LiDAR Quality Assessment Report

Materials Received: <input type="text" value="5/15/2012"/>	Project Type: <input type="text" value="GPSC"/>
Project ID: <input type="text" value="San Luis Valley LiDAR"/>	Project Description: <input type="text" value="V13, 1.0 Meter NPS LiDAR"/>
Project Alias(es): <input type="text"/>	Year of Collection: <input type="text" value="2011"/>

San Luis Valley LiDAR

CO_San-Luis-Valley_2011

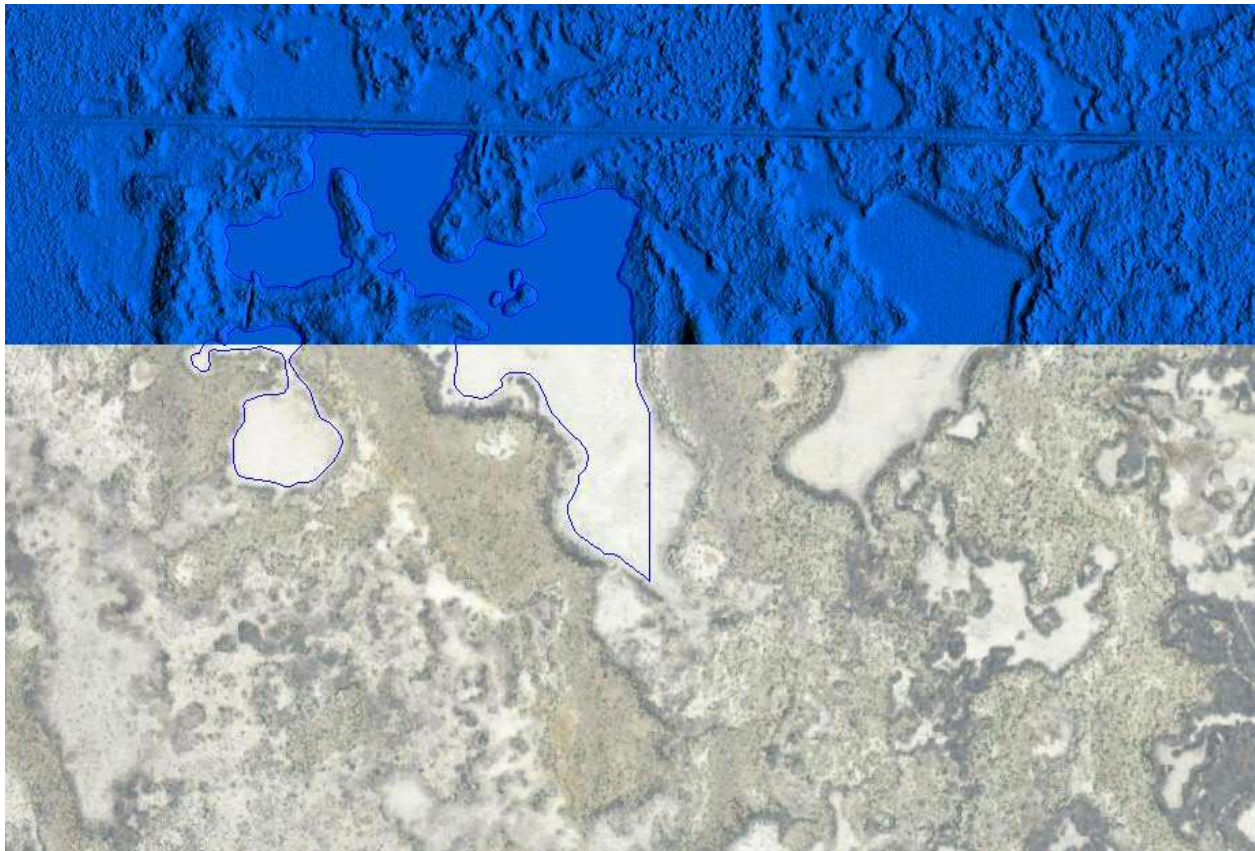
Above, we see we see an instance of waterbodies flattened and their respective breaklines. It is evident from the orthoimagery and DEM that there is a waterbody located to the right that was not flattened; however, there is sufficient density (lack of heavy tinning) within that waterbody to suggest that this feature was either dried up or very shallow at the time the LiDAR was flown. Some of these areas have been marked in the "DEM Error Tags" shapefile. However, unless there is heavy tinning, these areas are acceptable as is.

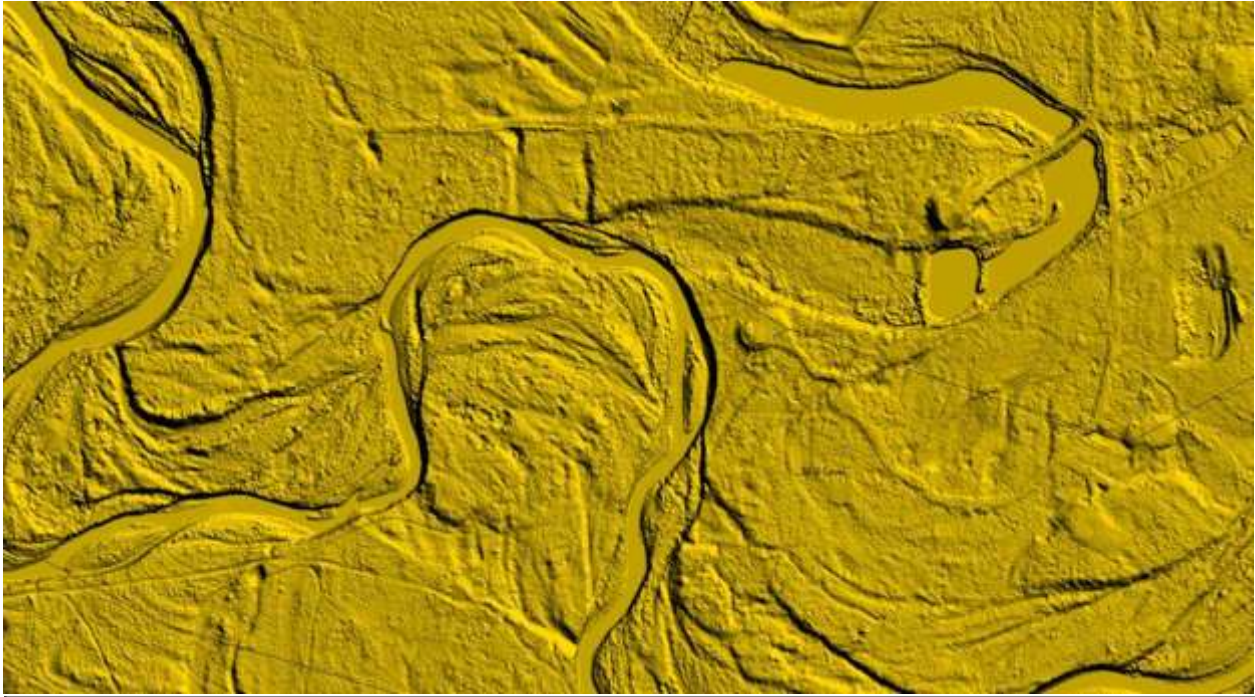
Pictured is an image of the Redelived Data, clearly the Rio Grande was hydro Flattened throughout the dataset and the issues below relating to double-line streams have been corrected.

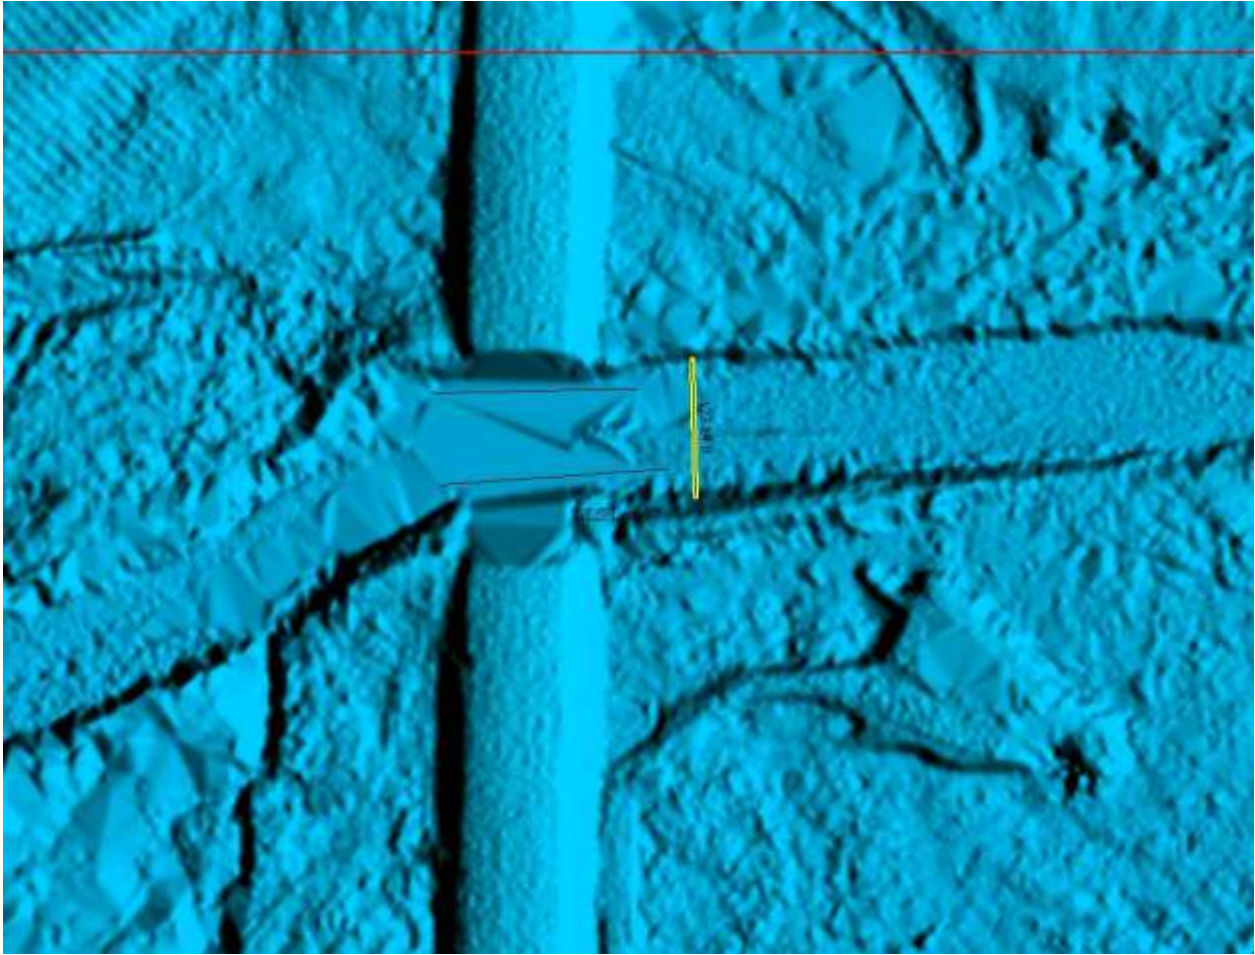
Pictured here is a portion of the Rio Grande River, a Double Line Stream (DLS), this particular section is greater than 100 Ft. across and should have been bank to bank hydro flattened with monotonic flow. The V13 LiDAR specification calls for flattening of streams 100ft across in diameter, even if portions of the stream go under that 100 Ft. metric at times ("100' nominal width: This should not unnecessarily break a stream or river into multiple segments. At times it may squeeze slightly below 100' for short segments.). Further, those portions going under 100 Ft. should still be hydro flattened. While a good portion of the Rio Grande and other rivers were hydro flattened there are still areas not flattened that exhibit heavy tinning. These areas have been marked, in part, in the "DEM Error Tags" Shapefile; however, only in sections to highlight the issue, this is not to say that only those sections need be fixed, the river as a whole needs to be treated.

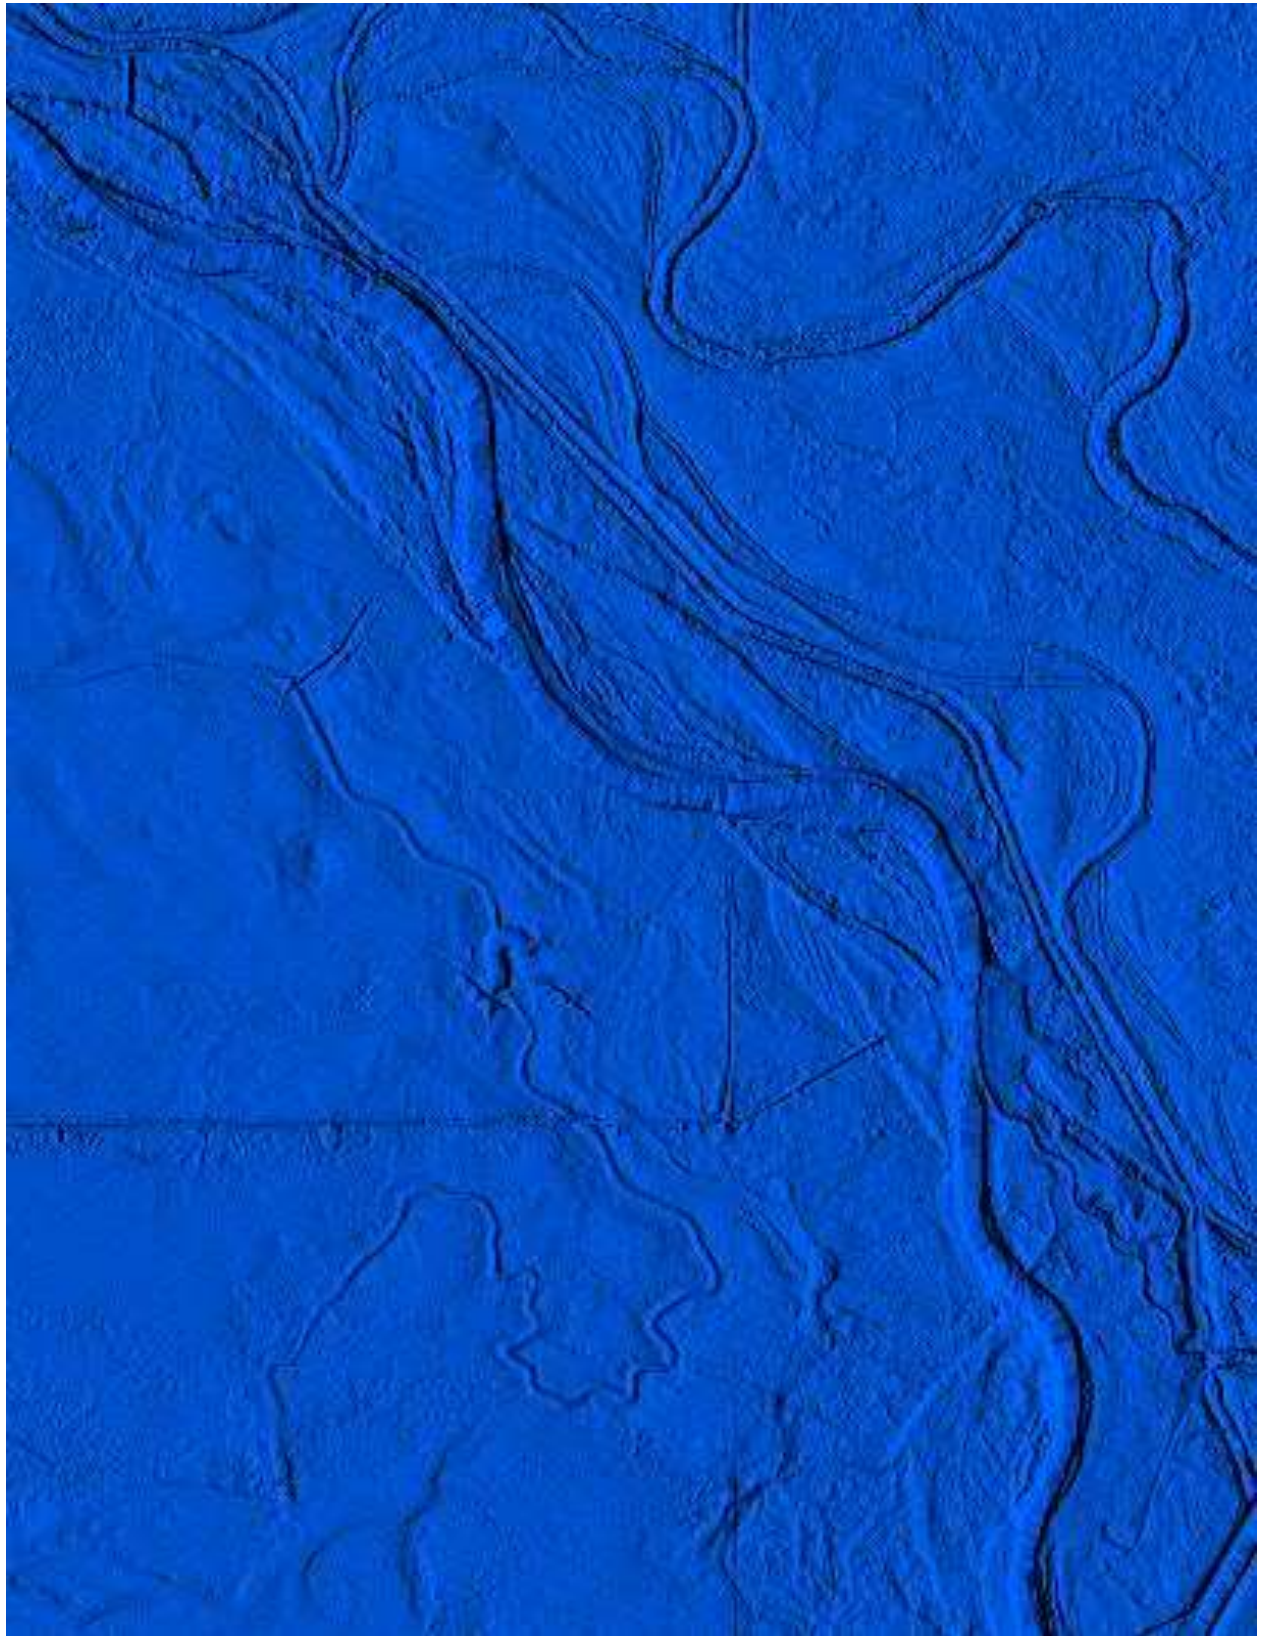
Here is another section of a DLS River that exhibits heaving tinning. In this instance the bank to bank distance is just under 100ft for some distance, but still connects to larger portions of the river further upstream and downstream.

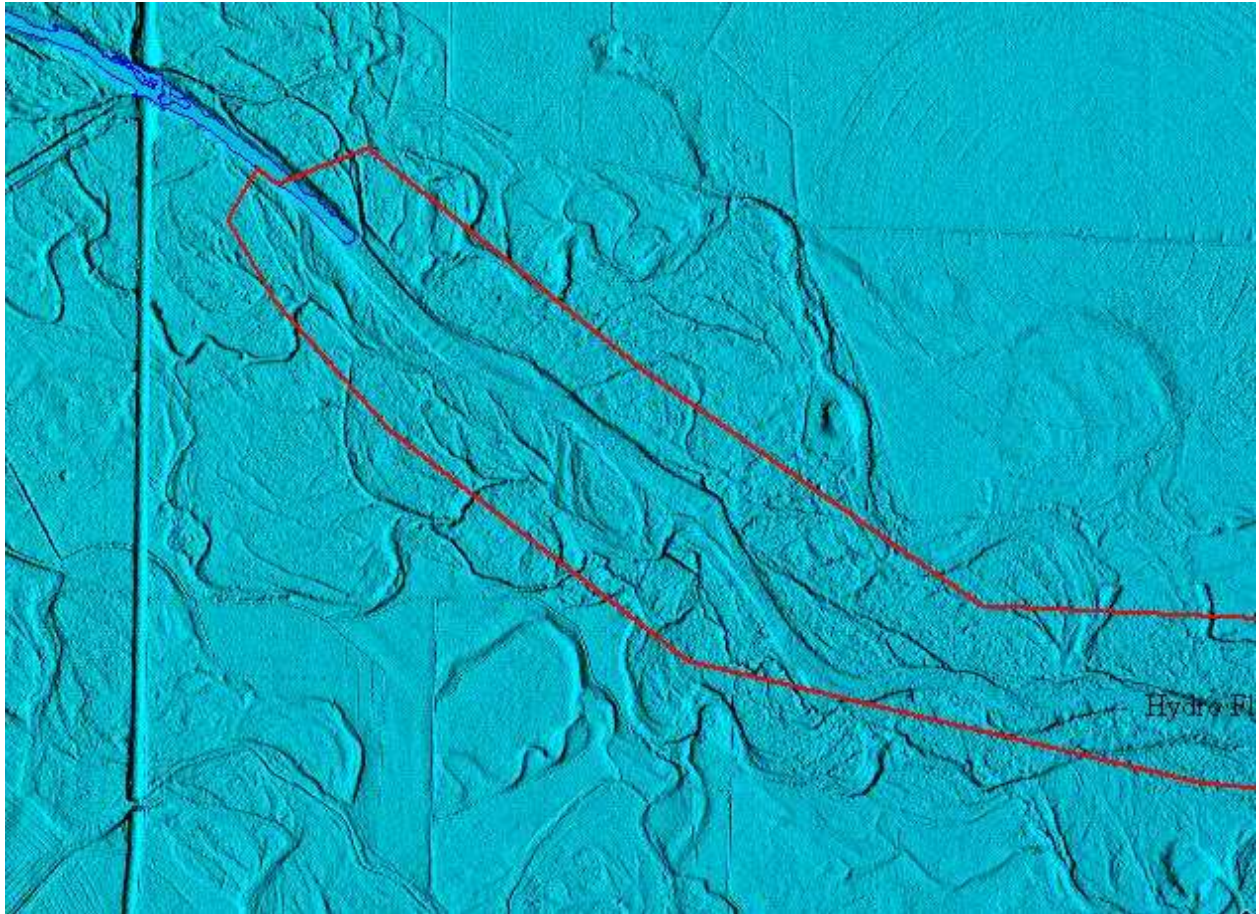
Here is an image showcasing inconsistent treatment of the DLS. The breakline and hydro flattening ends abruptly.

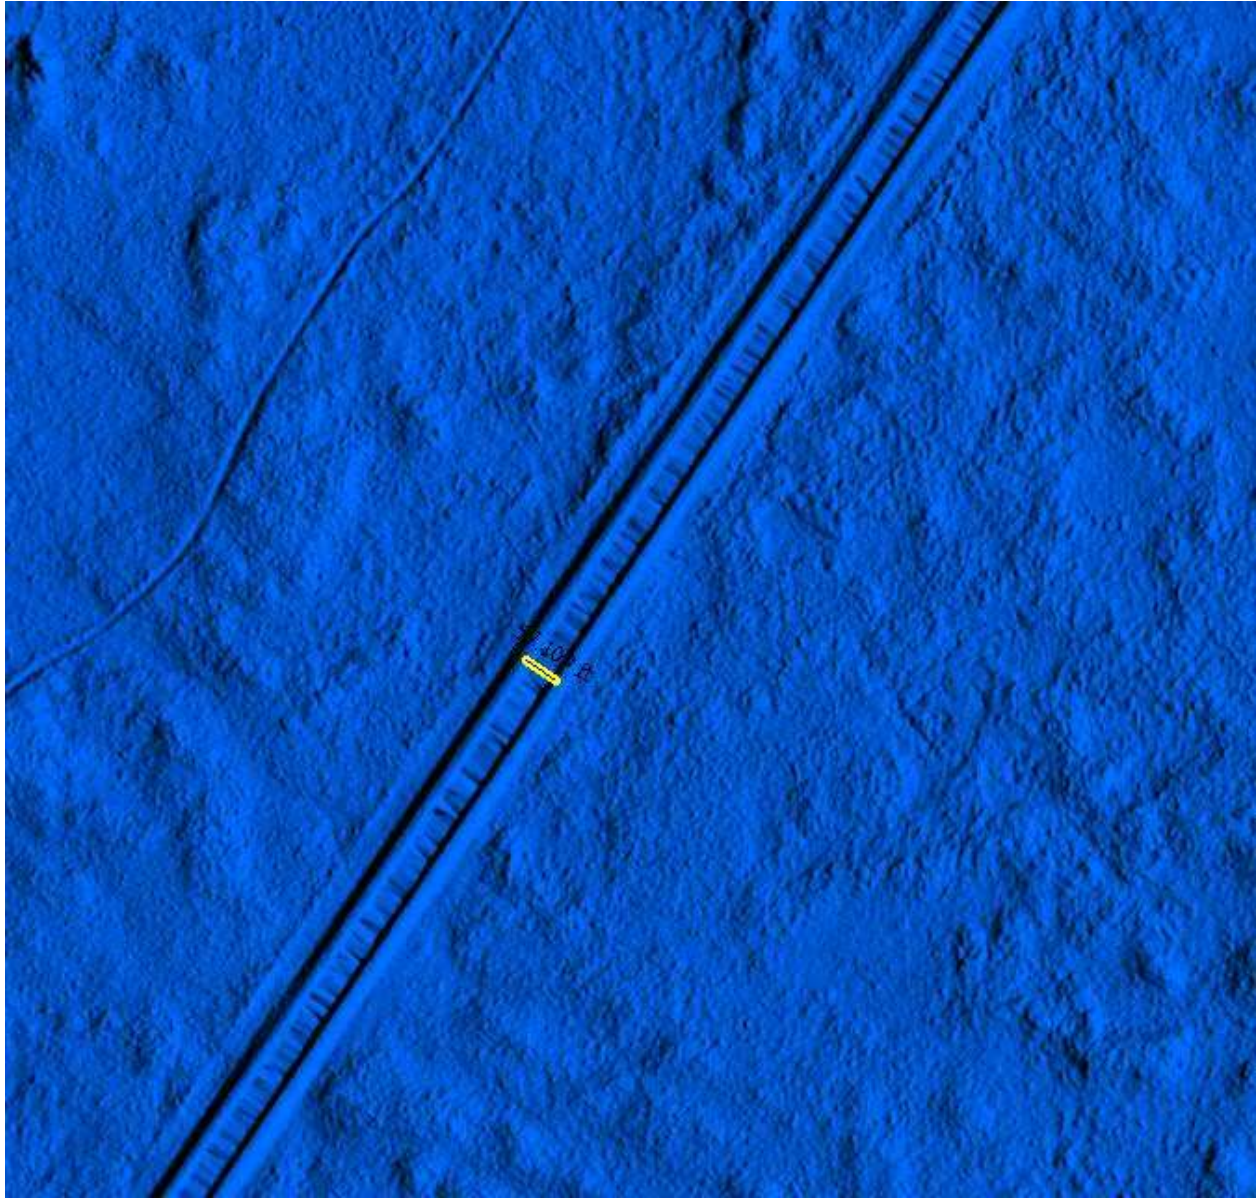
Pictured here is a less than 100ft nominal width Canal which exhibits heavy tinning and does not technically need to be "Hydro Flattened" because it does not grow greater than 100ft at any point.

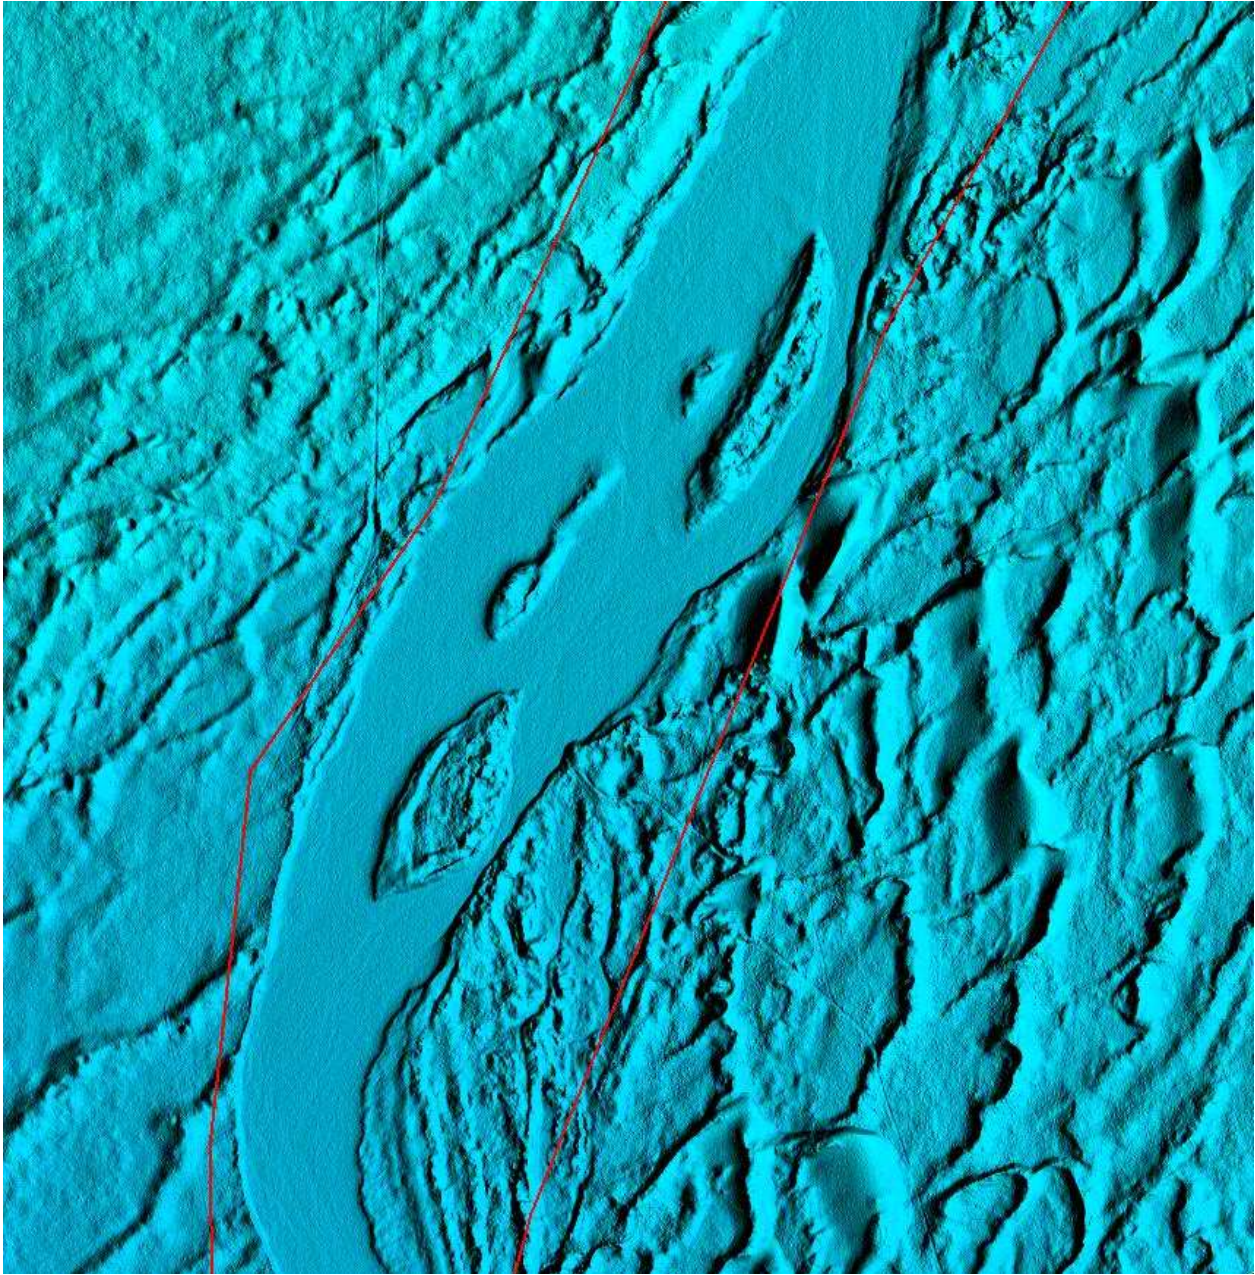
*Determined this is acceptable.
Above is a DLS which has a greater than 100ft nominal width (near the sand dunes), but was not flattened. As with many of the retention ponds and waterbodies, it exhibits higher point density and little tinning indication dry or shallow conditions and need not be flattened.

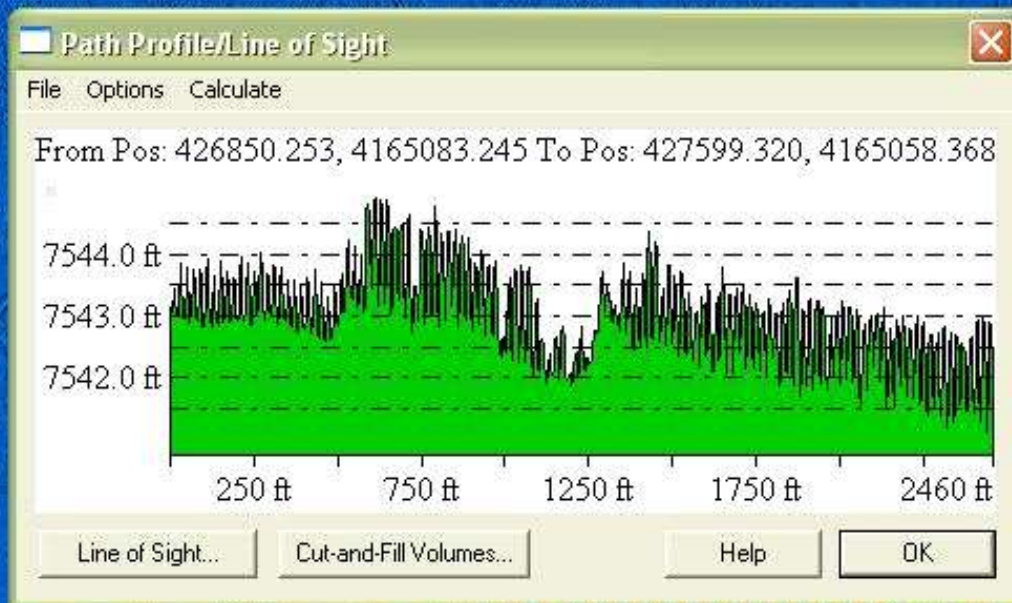
The Vendor provided the USGS with the statement that this project was flown over multiple dates and during crop harvest, leaving some strange patterns in many of the crop circles. Of concern however, is how well filtered the point cloud was in order to derive the Bare Earth in these areas, if only last returns and first and only returns were used, then there may be little the vendor could do to make the elevations more consistent as last returns and first and only returns will unavoidable not all penetrate to the actual ground. However, the profile graph pictured above does beg the question of if some more extensive manual editing could be performed to eliminate the spikes pictured above. Many, though by no means all of these are marked in the "DEM Error Tags" Shapefile.
